Project Name: Council Rock School District
Newtown Elementary School Chiller Replacement
DEI Project No. 283091

*This Addendum forms a part of the Contract Documents and modifies the original Bidding Documents dated **February 2024**. This addendum must be acknowledged on the Bid Form in the space provided for this purpose. Failure to so acknowledge this addendum may subject the Bidder to disqualification.*

1.1 This addendum consists of 5 pages including the following attachments:

Sheet No.
H-2.1

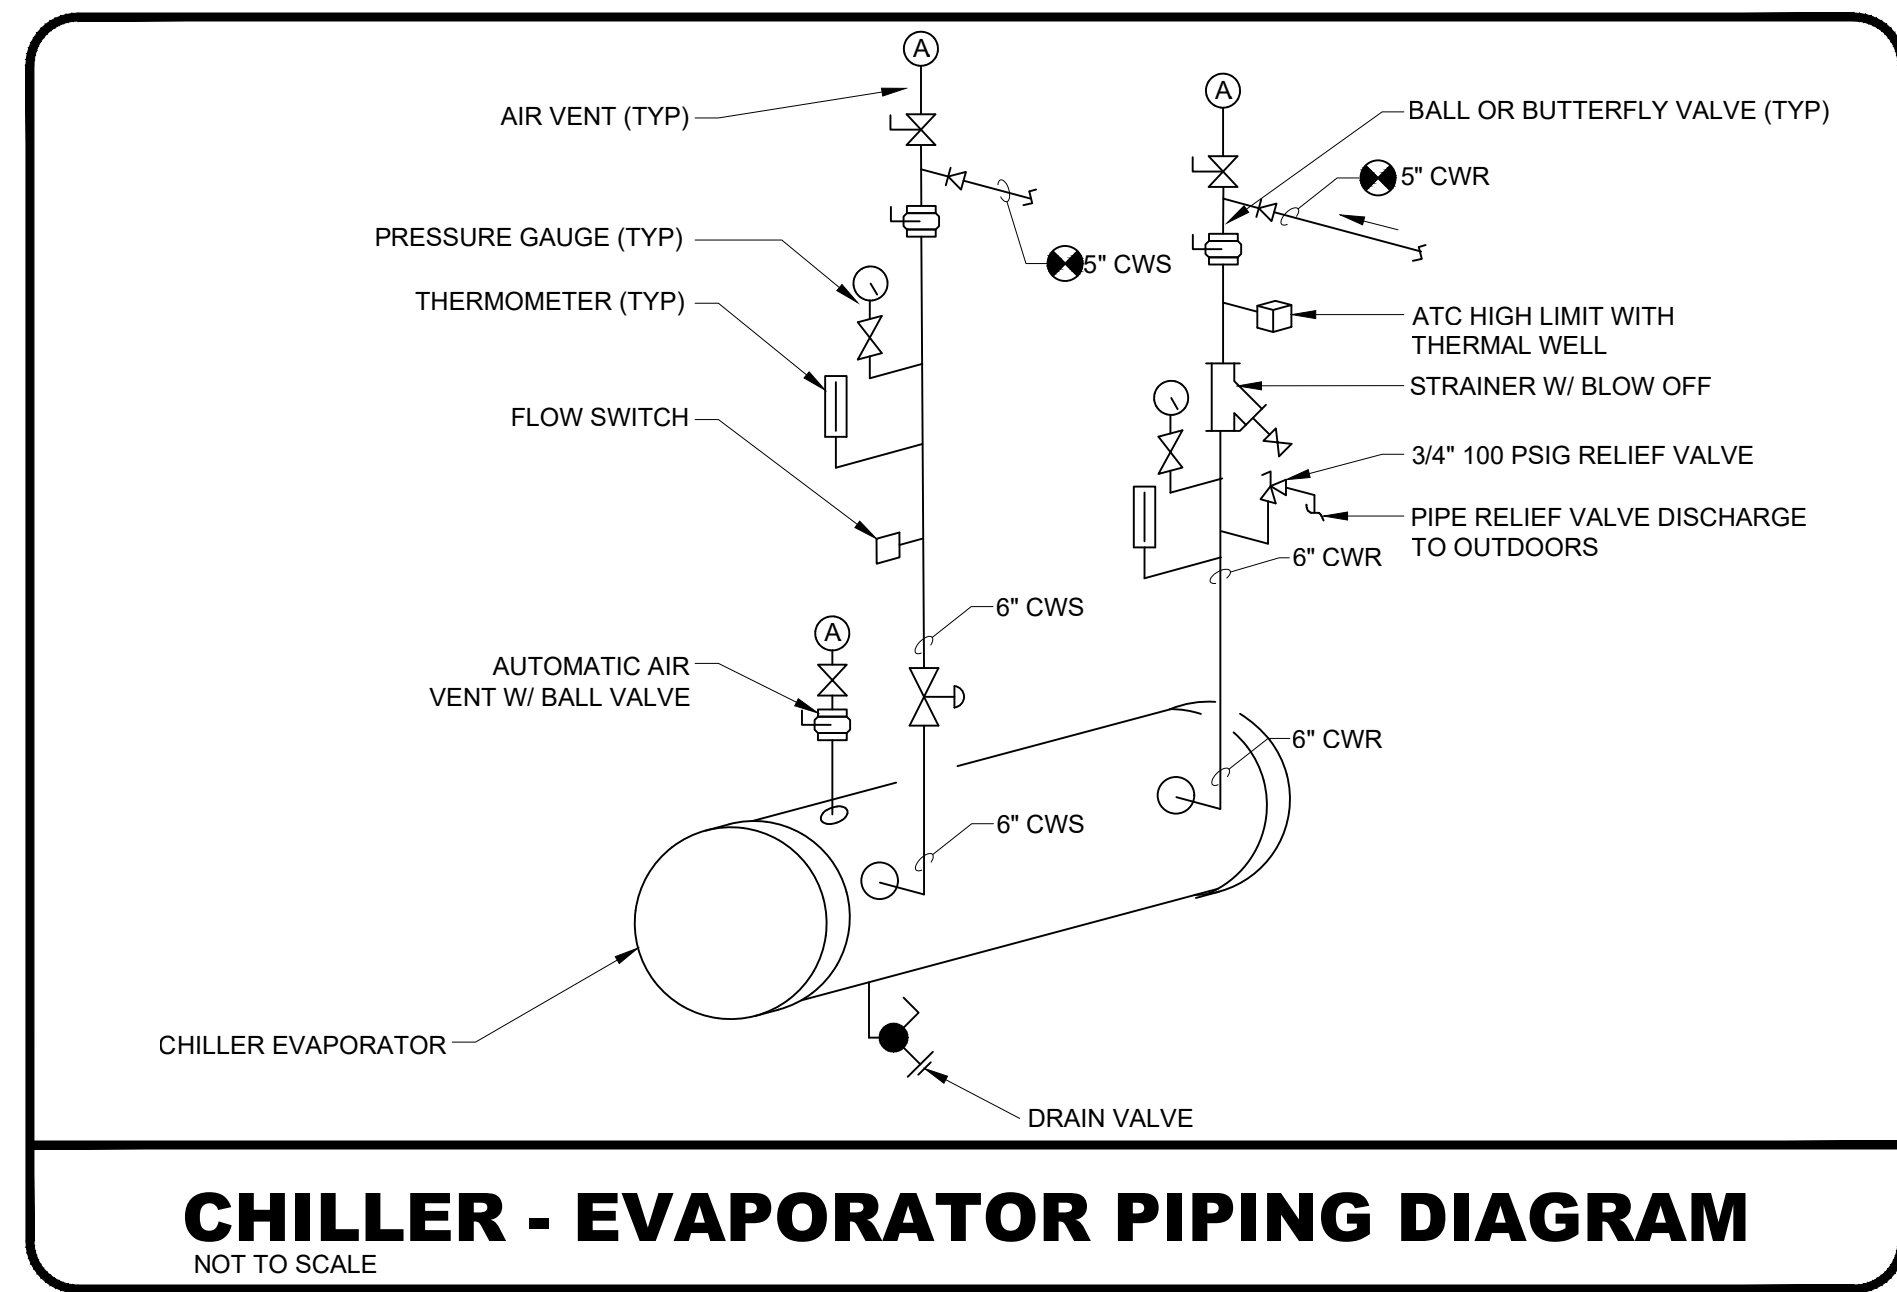
5.1 Drawing H2.1 “Partial Mech Room / Chiller Plan - Demolition and New Work” **REVISE** the current drawing as follows:

- a. Replace existing pump motor starters with variable frequency drives for existing chilled water pumps P-6 and P-7.
- b. Revise Key Note #6 pertaining to existing glycol feeder drain valve.

- 6. INSTALL DRAIN VALVE IN ASSOCIATED EXISTING GLYCOL FEED PUMP SYSTEM. PROVIDE DRAIN VALVE w/THREADED HOSE CONNECTION AND CAP
 - 7. INSTALL NEW PIPE SUPPORT.

- 8. PROVIDE VFD-P6, RECONNECT TO EXISTING ATC SYSTEM.
 - 9. PROVIDE VFD-P7, RECONNECT TO EXISTING ATC SYSTEM.
 - 10. EXISTING PRESSURE RELIEF VALVE TO REMAIN. COORDINATE P-6, P-7 MINIMUM SPEED SETTINGS w/ENGINEER.
